The present document correct some editorial errors in the official document ECE/TRANS/WP.29/GRE/2018/44, we discovered after its publication. The following paragraphs shall replace the corresponding paragraphs in the above cited official document or are added to it.

Model B  
(See paragraph 4.5. of this Regulation)

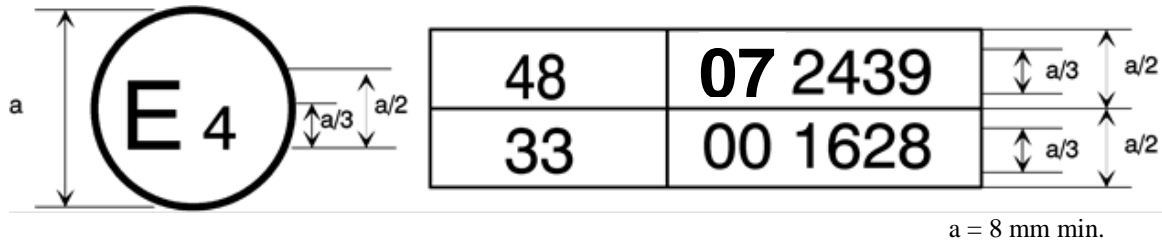
The above approval mark affixed to a vehicle shows that the vehicle type concerned has been approved in the Netherlands (E 4) pursuant to Regulation No. 48 as amended by the **07** series of amendments and Regulation No. 33.<sup>1</sup> The approval number indicates that, at the dates when the respective approvals were given, Regulation No. 48 was amended by the **07** series of amendments and Regulation No. 33 was still in its original form.
